# ACT vs TDD Comparison: Evidence Based Results

Contribution to 802.3dm Task Force

This presentation points out some of the errors in the presentation “ACT and TDD Comparison”, by Claude Gauthier and Frank Wang

We request that the authors correct these errors

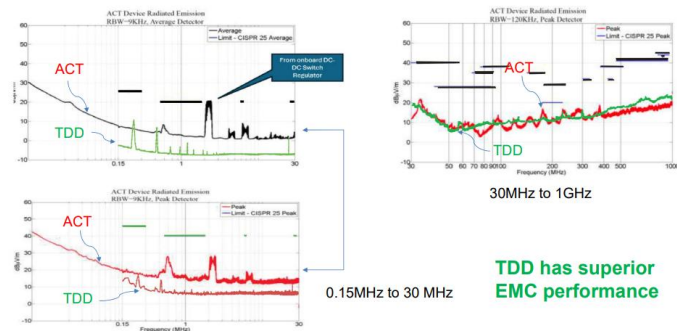
**Misleading:** What was timing, bandwidth, and frequencies for DL/UL tested?

Is this TDD or ASA?

If the above differs ASA is not TDD as specified [Evolution of 802.3dm: From GMSLE to ACT and Beyond](#)

Review **Slide 9** – TDD is Time driven ASA is Protocol driven

## Overlay Comparison of EMC Results Presented at IEEE

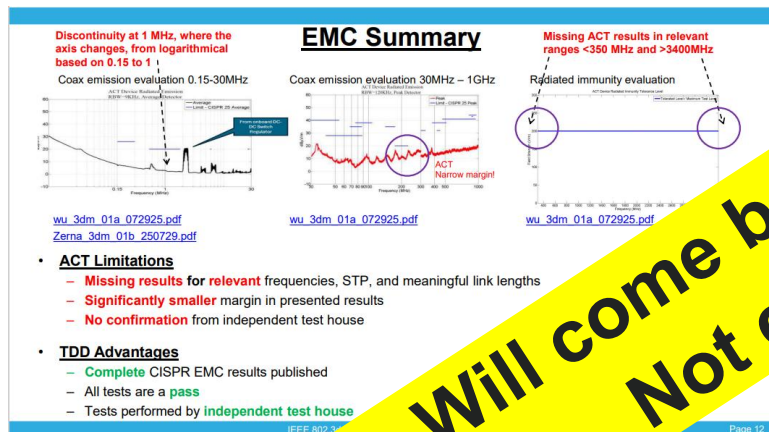
**Misleading:** Is this TDD or ASA? Please specify exact timing

**Misleading:** ACT tested Crystal-less and PoC – TDD did not

Review **Slide 3**

**Incorrect:** to compare the noise floor (where there are no peaks) between different CISPR25 measurements.

The noise floor depends on the equipment used in the test (LNA noise figure, spectrum analyzer type), independent of the modulation type.

**Misleading:** Radiated emissions is very dependent on board and cable type.

It is not valid to compare different test setups for relative performance.

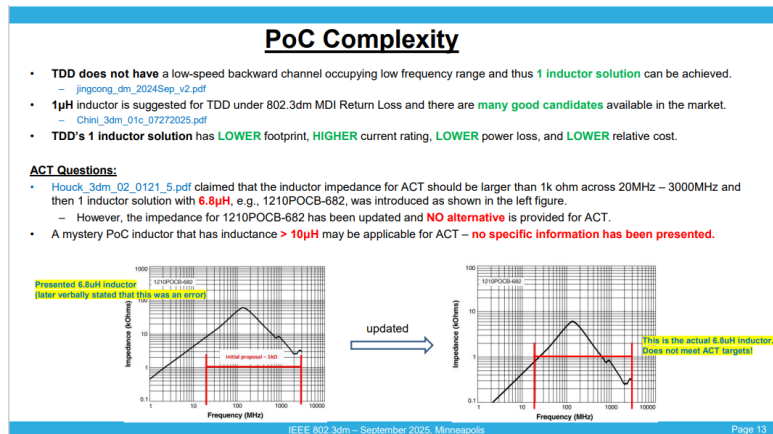
**Misleading:** Does the 1uH TDD 1 inductor solution work with EMC and 15 meters with 4 in-line cables?

**Incorrect:** Return Loss does not prove a valid solution

**Incorrect:** TDD requires impedance – no discussion – review impedance presentation again and comparison presentation on why this is critical

No discussion of **slide 19** on TDD, higher bandwidth than ACT and low frequency baseline wander issues

Baseline wander issues for TDD (Low frequency)

Why Impedance Matters – review full presentation and explain why TDD does not require impedance when Low frequency content is present

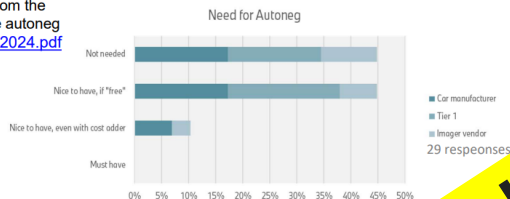
**Incorrect:** Differential Manchester Encoded (DME) modulation is a mature and robust method which has been used for decades in communications

**Incorrect:** Clause 98 is an optional part of the ACT proposal and has nothing to do with ACT crystal-less operation

**Incorrect:** Incoming signal does not have better jitter properties than a DME ACT signal with proper timing recovery.

## PHY-level Sync

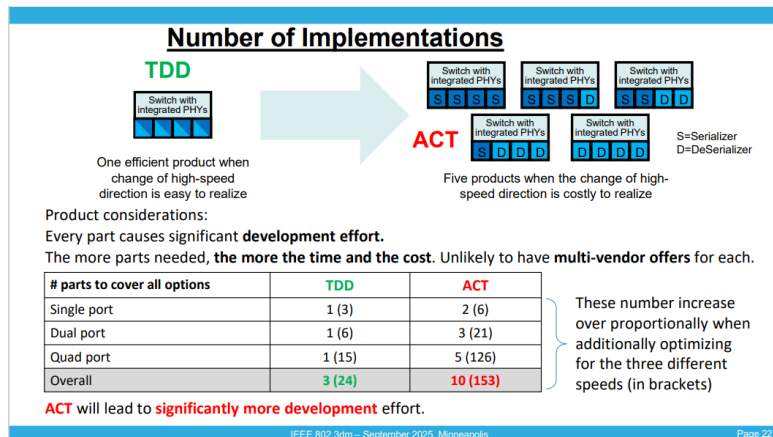
Delay compensation is a feature that can be implemented in ACT. SERDES accomplishes delay compensation without TSN

ACT does not require hardware and software changes it has built in low latency behavior

**Incorrect:** TSN is not required for ACT

**Incorrect:** ACT GPIOs are fast acting stated last September (Hamburg) and was the reason ASA-MLE did not move forward and TDD is now proposed, due to latency issues.

Where did the 5.3ns accuracy come from? No link or calculation or method explaining.

No reasoning behind why this is needed for customers and more importantly why the standard needs this
